Title - Sujet Renovation Room#2044-2046	
Solicitation No. - N° de l'invitation 01965-180572/A	Amendment No. - N° modif. 007
Client Reference No. - N° de référence du client 01965-180572	Date 2017-12-15
GETS Reference No. - N° de référence de SEAG PW-\$\$\$FG-356-73683	
File No. - N° de dossier fg356.01965-180572	CCC No./N° CCC - FMS No./N° VME
Solicitation Closes - L'invitation prend fin at - à 02:00 PM on - le 2018-01-09	Time Zone Fuseau horaire Eastern Standard Time EST
F.O.B. - F.A.B. Plant-Usine: <input type="checkbox"/> Destination: <input checked="" type="checkbox"/> Other-Autre: <input type="checkbox"/>	
Address Enquiries to: - Adresser toutes questions à: Steele, Harold	Buyer Id - Id de l'acheteur fg356
Telephone No. - N° de téléphone (873) 469-3596 ()	FAX No. - N° de FAX (819) 956-8335
Destination - of Goods, Services, and Construction: Destination - des biens, services et construction:

ADDENDUM N°: 003

Project Number: 01965 18 0572

The following changes in the bid documents are effective immediately. This addendum will form part of the contract documents.

CASEWORK PLAN
A-103.2 SCALE 1:10

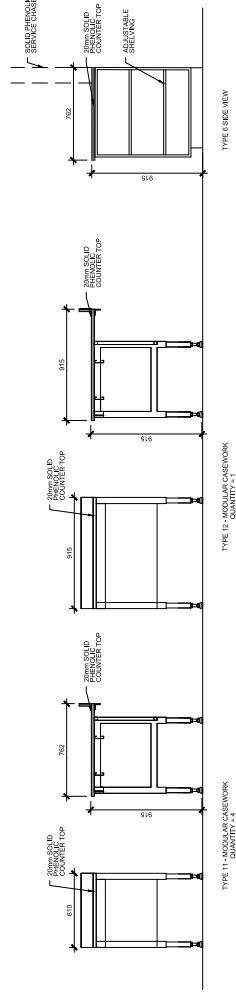
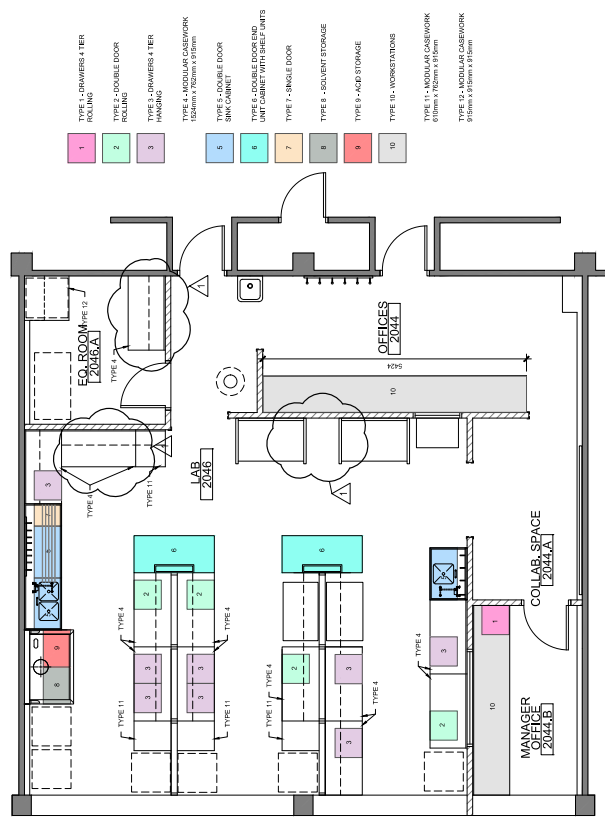
1. Refer to A-103.2 Casework Details Revision 1 (12/01/2017) for modifications to casework components.

1 AAFC LAB RENOVATION - POWER PLAN

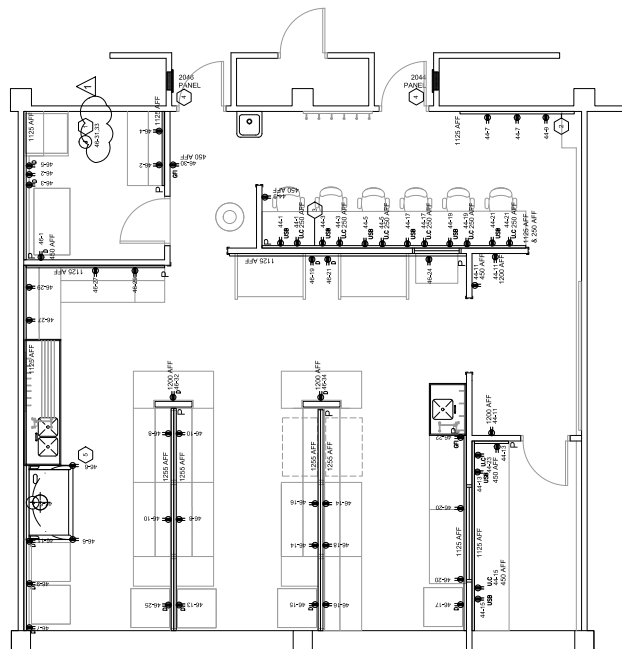
1. Refer to EP-101 Power Plan Revision 1 (12/07/2017) for modifications to Fan Coil Unit wiring requirements and clarification of panel wiring note.

1 HVAC PLAN
M-101
SCALE 1/8"

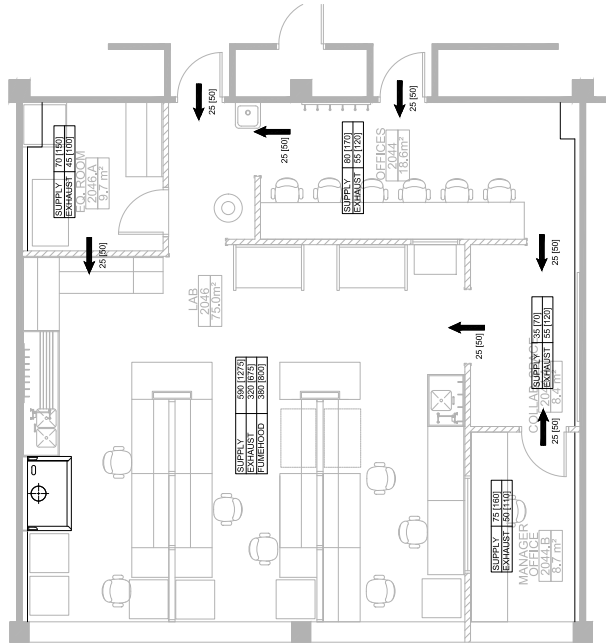
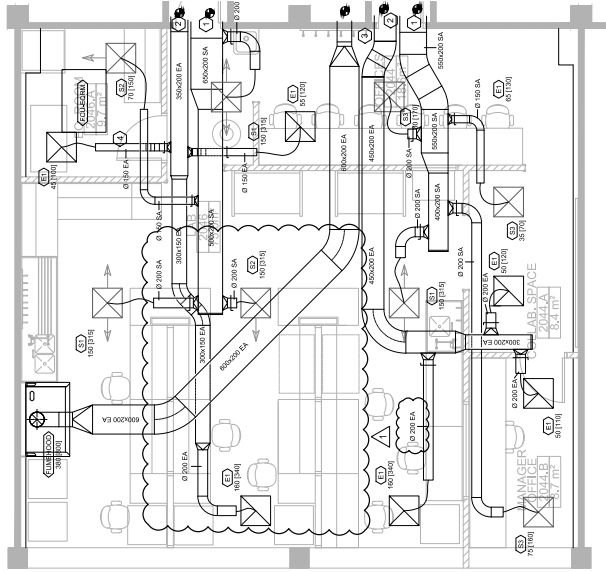
1. Refer to M-101 HVAC Plan Revision 1 (12/01/2017) for modifications to ductwork positioning and sizing.

1 PLUMBING SUPPLY PIPING LAYOUT
P-101 SCALE 1:50

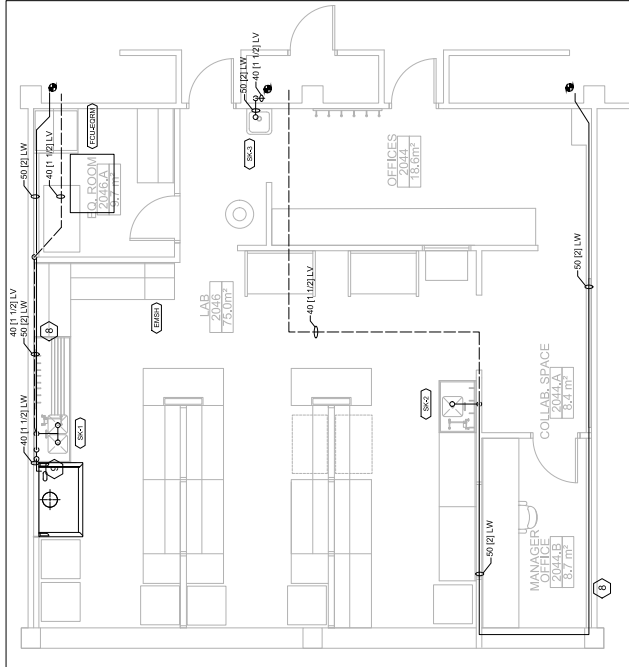
1. Refer to P-101 Plumbing Plan and Schedules Revision 1 (12/01/2017) for modifications to Reverse Osmosis service piping, and additional notes regarding gas piping requirements.
